30% Preliminary Design
Value Engineering Report

TOWN OF MASHPEE, MASSACHUSETTS
MASHPEE SEWER COMMISSION
PRELIMINARY DESIGN OF MASHPEE WATER
RESOURCE RECOVERY FACILITY (WRRF)
30% REVIEW SUBMITTAL

NOVEMBER 2019
11188223

2 PLANT WATER SCHEMATIC
NOT TO SCALE

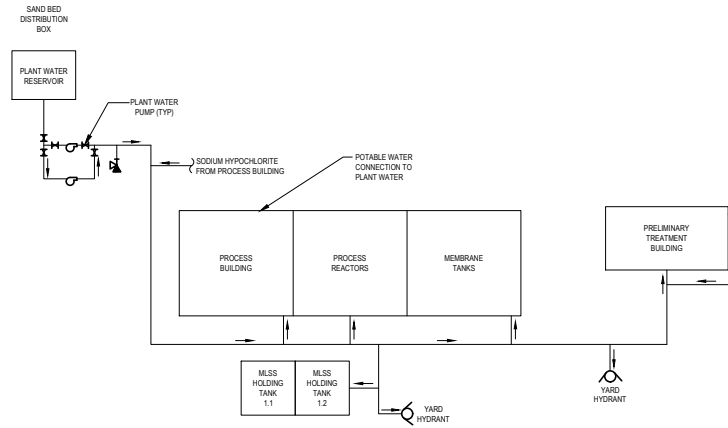
3. Suggest adding flushing water connections to chemical feed piping header for maintenance/repairs and safety.
4. Drawing M-006 – A provision for a plant water flow meter may want to be considered.

PRELIMINARY TREATMENT BUILDING - PLAN

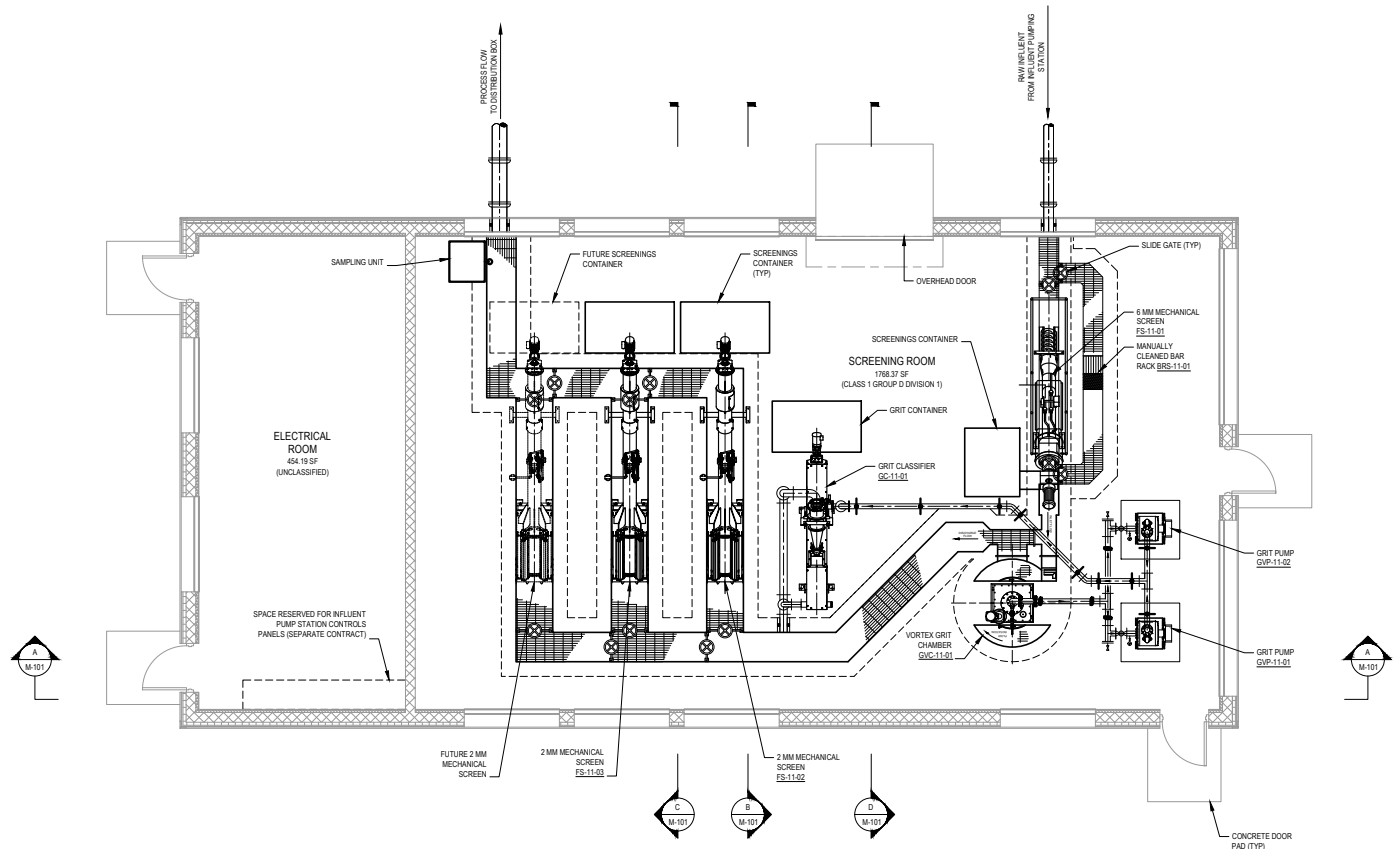
5. Drawing M-100 – it is suggested that the screening room have a wash/yard hydrant.
6. Drawing M-200 – It is suggested that an office/lab building be constructed for the operators. Also, a parts storage and work area with bench is also highly recommended.

PROCESS BUILDING - FIRST FLOOR PLAN
SCALE: 1/8" = 1'-0"

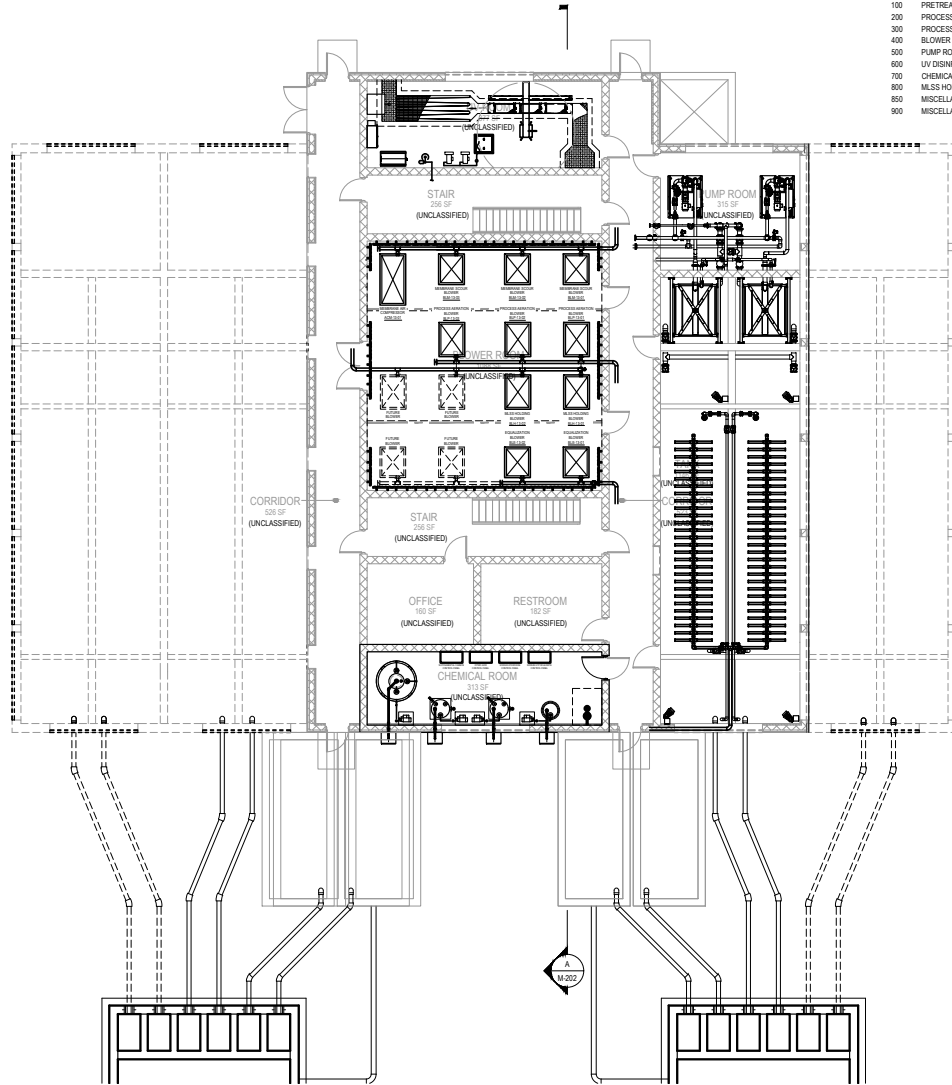
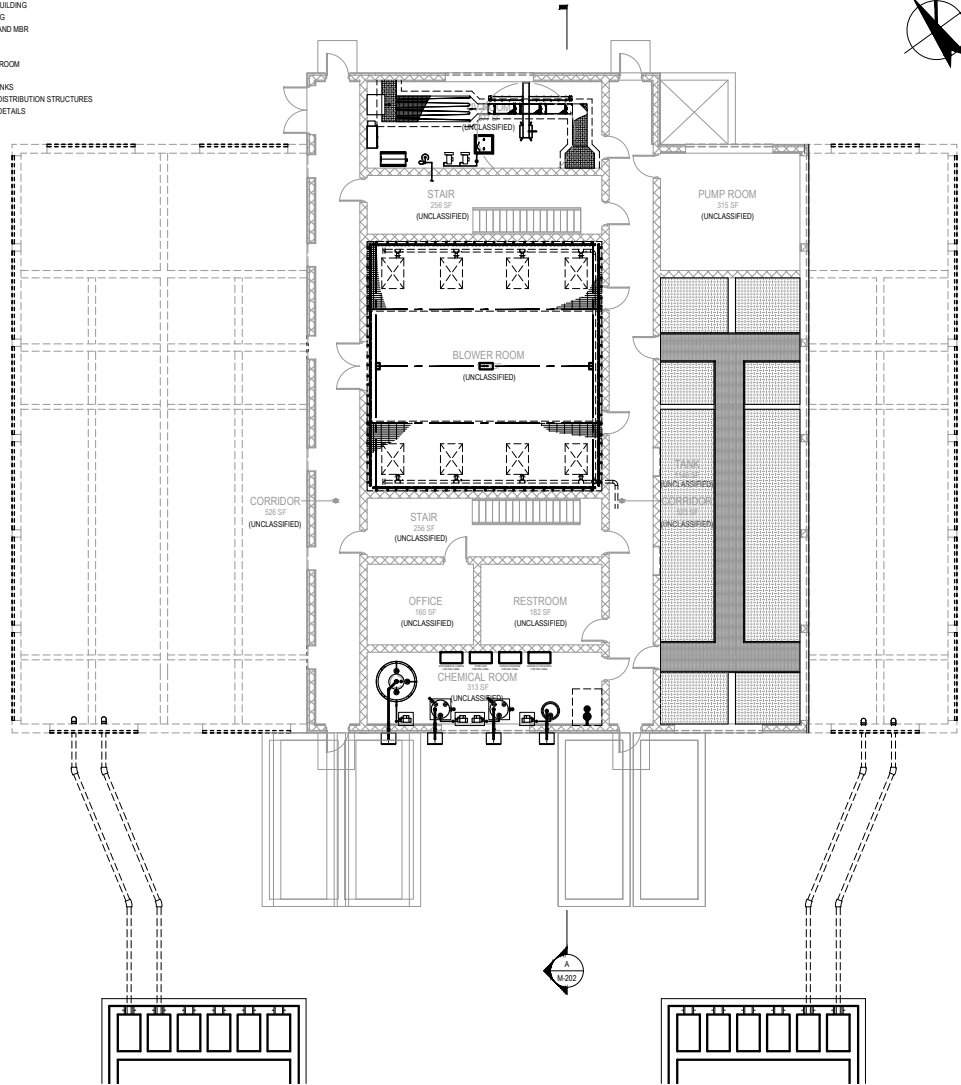
VE CONCEPT			
Project: Mashpee WWTF Preliminary Design		Idea No. P-1	Page No.
Process Area/Category: Process Building			
TITLE: Reducing Building Space		Weighted Total:	
		Ranking:	
ORIGINAL CONCEPT: PROCESS AREA/CATEGORY			
Drawings M-200 through M-202 shows a building space over the anoxic and aeration process tanks, incorporated as part of the process building.			
ALTERNATIVE CONCEPT:			
We understand the town's goal is to enclose the plant as much as possible to improve aesthetics and odor control. It does appear that this goal can be achieved with some limited changes to the building as depicted. The process trains as planned can be turned perpendicular to the buildings, and the building only extended over the membrane segments and permeate pump room. The remaining tankage can be buried outside the building, with hatches for access. This will greatly reduce building footprint, save significant capital costs, and save in heating/ventilating costs. The building over these tanks offers limited advantages, and presents challenges. The outside aesthetics can be improved with good design and landscape approaches (e.g. grass or plantings over the tankage), and a smaller building will have a lower overall aesthetic impact on the area (especially for distant sightline neighbors).

VE CONCEPT			
Project: Mashpee WWTF Preliminary Design		Idea No. B-1	Page No.
Process Area/Category: Process Building			
TITLE: Architectural - Duplicative Features		Weighted Total:	
		Ranking:	
ORIGINAL CONCEPT: PROCESS AREA/CATEGORY			
In drawings M-200 and A-200, two long corridors and two large stairwells are shown inside the process building.			
ALTERNATIVE CONCEPT:			
The two long corridors do not serve as functional space. One can be deleted completely from the floor plan. Some of the building space assigned to corridor can possibly be repurposed.			
One of the two large stairwells can be maintained, and one can be replaced with a simpler secondary egress stairs. The space allowed for one stairwell is likely sufficient for the two separated stairs.			
ADVANTAGES:		DISADVANTAGES:	
<ul style="list-style-type: none"> • Building footprint can be reduced. 			
COST SUMMARY		Initial Cost	O&M LCC
Original Concept	\$	\$	\$

VE CONCEPT			
Project: Mashpee WWTF Preliminary Design		Idea No. B-2	Page No.
Process Area/Category: Process Building			
TITLE: Control Room		Weighted Total:	
		Ranking:	
ORIGINAL CONCEPT: PROCESS AREA/CATEGORY			
In drawings M-200 and A-200, a room labeled “Office” is shown in the Process Building.			
ALTERNATIVE CONCEPT:			
Consider changing the “Office” shown in the Process Building to be a “Control Room”. The plan does not otherwise provide a place for the head end SCADA to be viewed and operations manuals, records, etc. to be available for operator troubleshooting. A desk in this space and file storage may be supplemental uses for the space as well.			
ADVANTAGES:		DISADVANTAGES:	
<ul style="list-style-type: none"> Combine “Office” Space and SCADA system space into one room. 			
COST SUMMARY		Initial Cost	O&M LCC
Original Concept	\$	\$	\$
Alternative Concept	\$	\$	\$
Additional Savings	\$	\$	\$
Team Member: Kent M Nichols, Jr., P.E.		Discipline: Wastewater Process

VE CONCEPT			
Project: Mashpee WWTF Preliminary Design		Idea No. B-3	Page No.
Process Area/Category: Process Building			
TITLE: Restrooms		Weighted Total:	
		Ranking:	
ORIGINAL CONCEPT: PROCESS AREA/CATEGORY			
The drawings M-200 & A-200 show a single restroom with one access in the Process Building.			
ALTERNATIVE CONCEPT:			
We recommend consulting formally with the local Building Department as to requirements for separate men's and women's toilet facilities, and related code requirements. If two restrooms are needed in the initial building, then the plans should be adjusted for the required space. Provisions are needed for a shower area, and in a smaller facility this may be best set up as a separately accessed room.			
ADVANTAGES:		DISADVANTAGES:	
COST SUMMARY		Initial Cost	O&M LCC
Original Concept	\$	\$	\$
Alternative Concept	\$	\$	\$
Additional Savings	\$	\$	\$
Team Member: Kent M. Nichols, Jr. P.E.		Discipline: Wastewater Process

7. Drawing M-200 – To help with pump, blower, and mechanical equipment removal, ramps are suggested for outside of the double doors in the corridor.
8. Drawing M-200 – It is suggested that the chemical room have a dual entrance with glass windows in the doors.

PROCESS BUILDING - LOWER LEVEL PLAN

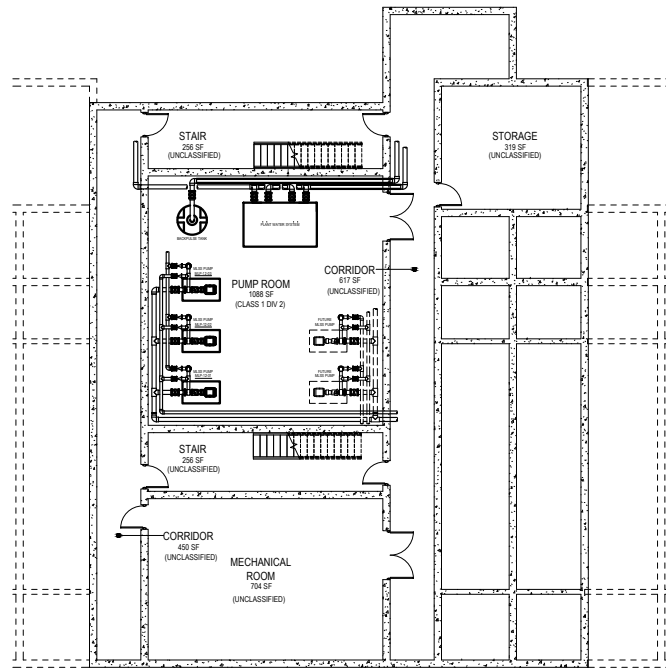
9. Drawing M-201 – Is crane access to the lower level provided to allow pump removal/installation as opposed to carrying equipment up and down the stairs?

PROCESS BUILDING - SECTION
 SCALE: 1/4" = 1'-0"
 0 2' 4' 8'

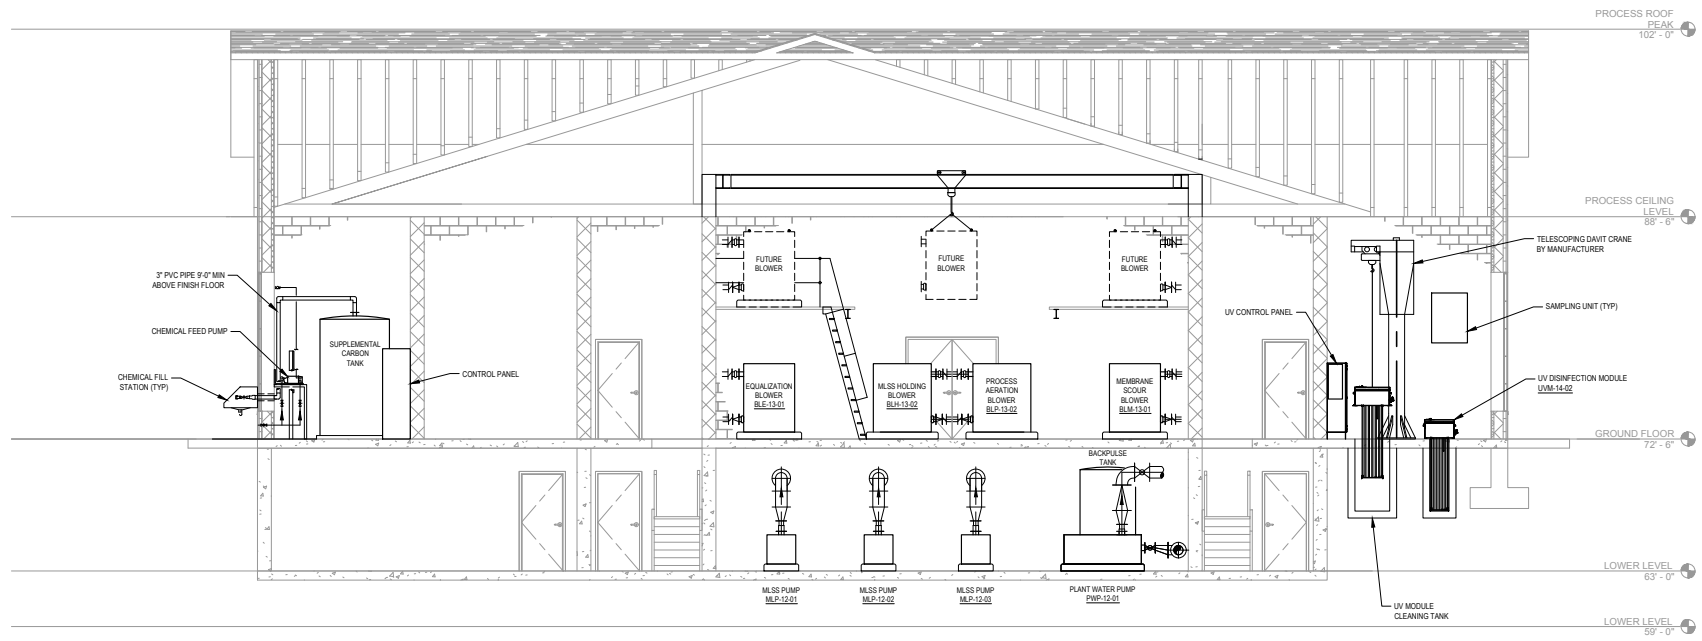
VE CONCEPT			
Project: Mashpee WWTF Preliminary Design		Idea No. B-6	Page No.
Process Area/Category: Process Building			
TITLE: Basement Height		Weighted Total:	
		Ranking:	
ORIGINAL CONCEPT:			
<p>The elevations shown on drawing M-202 shows a floor to floor elevation difference of 9'-6" for the lower level/pump room.</p>			
ALTERNATIVE CONCEPT:			
<p>Check with structural design group before planning the building elevations in this area. The floor under the blower room will need to be supported by significant beams to support the blower area dead and live loads. The floor and beams must be accounted for in allowing a ceiling height sufficient for portable lifting equipment in the basement pump room. It is likely this elevation will need to be greater – more likely 12' floor to floor.</p>			
ADVANTAGES:		DISADVANTAGES:	
COST SUMMARY	Initial Cost	O&M LCC	Net Present Value
Original Concept	\$	\$	\$
Alternative Concept	\$	\$	\$

10. Drawing M-202 – It is suggested that a UV module storage/maintenance rack with wash water and drain availability.
11. Drawing M-300 – All submersible mixer/pump slide rails should be welded after installation into one continuous piece. We have experienced slide rail disassembly after installation. All slide rail systems should be constructed of stainless steel.

Client	TOWN OF MASHPEE, MA
Project	PRELIMINARY DESIGN OF MASHPEE WRRF
Title	PROCESS BUILDING - PARTIAL LOWER LEVEL PLAN - PROCESS TANKS AND MBR
Project No.	11188223
Original Date	
Arch D	Sheet No. M-300
Sheet	of

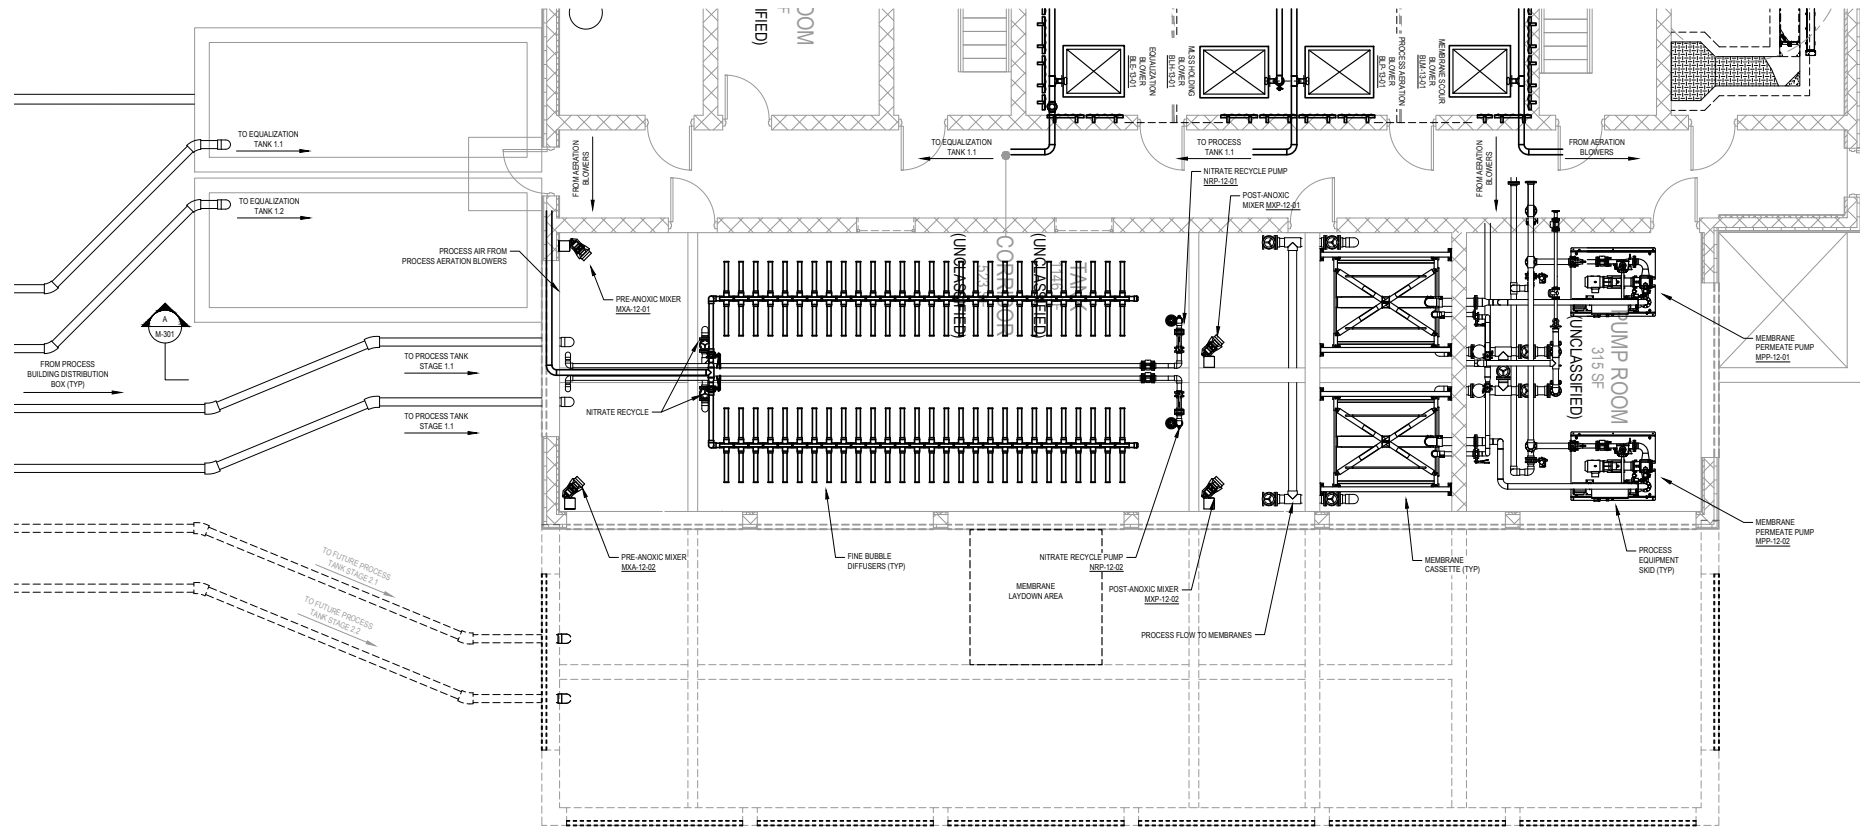
VE CONCEPT			
Project: Mashpee WWTF Preliminary Design		Idea No. P-3	Page No.
Process Area/Category: Process Building			
TITLE: Membrane Modules		Weighted Total:	
		Ranking:	
ORIGINAL CONCEPT: PROCESS AREA/CATEGORY			
<p>The drawings M-200 and M300 show two membrane modules for each Stage, and we understand the assumption is one would not be out of service for “no more than a day” to meet the design conditions.</p>			
ALTERNATIVE CONCEPT:			
<p>We recommend reviewing this approach, as redundancy for membranes should generally provide for a longer “out of service” period. Using two larger membrane sets, or adding a third smaller cartridge should be considered in the initial stage. As stages progress, fewer additional “separate” membrane racks/cartridges may be used (for example using larger cartridges may be effective as the plant capacity is increased).</p>			
ADVANTAGES:		DISADVANTAGES:	
<ul style="list-style-type: none"> • Membranes designed for appropriate “out-of-service” periods will allow more effective operation. • Initial membrane sizing should be selected to allow the best initial unit equipment pricing.

12. Drawing M-300 – Have the process tanks accessible for cleaning/maintenance with apparatus such as a Vactor or scavenger truck.
13. Drawing M-300 – Are the fine bubble diffusers removable from the tanks for cleaning and maintenance?

14. Drawing M-300 – A loading dock is suggested if possible.
15. Drawing M-400 – The plans show only one membrane air compressor. Is redundancy planned?

PROCESS BUILDING PARTIAL PLAN - BLOWER ROOM
SCALE: 1/4" = 1'-0"

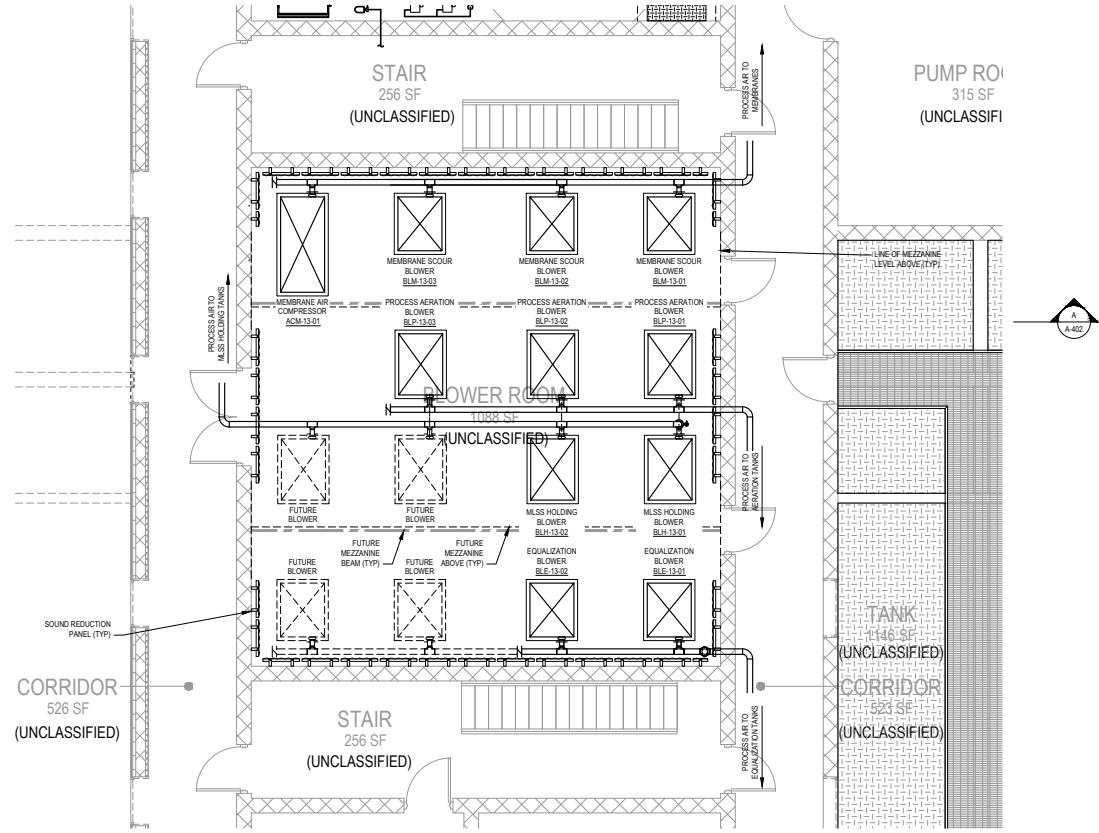
Drawing M-400 through M-402 provide information on the proposed monorail in the middle of the Blower Room.			
ALTERNATIVE CONCEPT:			
The monorail in this room seems to suggest limited functional use (it is shown to be located over the piping headers below, not the blowers). Ensure that the lifting system is suitable for the maintenance needs. If a monorail is not useful, consider alternatives. For example, the additional cost of a bridge crane may be justified, and should be reviewed.			
ADVANTAGES:		DISADVANTAGES:	
COST SUMMARY		Initial Cost	O&M LCC
Original Concept	\$	\$	\$
Alternative Concept	\$	\$	\$
Additional Savings	\$	\$	\$
Team Member: Kent M. Nichols, Jr., P.E.		Discipline: Wastewater Process

16. Drawing M-400 – Consider portable gantry vs the Monorail for potential cost savings and to avoid potential for misalignment. If monorails are not lined up properly, they can be more of a hinderance.

Arch D	Sheet No.	M-402	Sheet	of
--------	-----------	--------------	-------	----

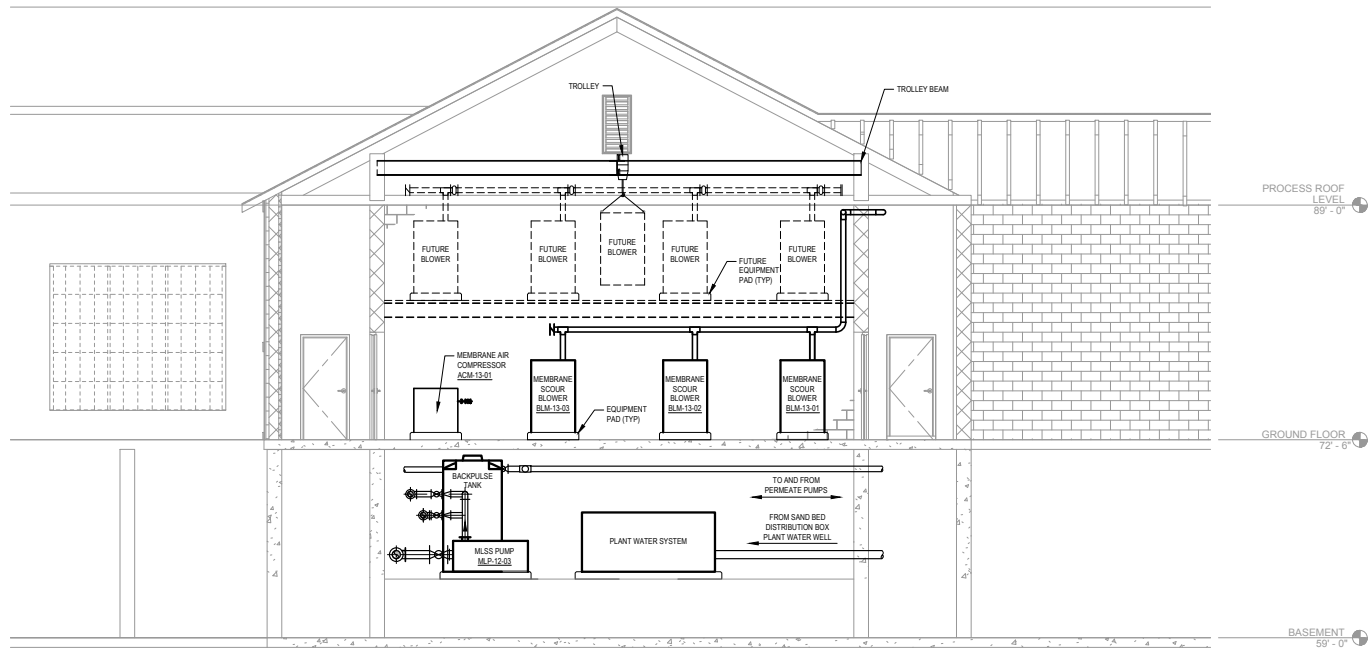
17. Drawing M-402 – Verify plant water system plumbing isolation for repairs etc.
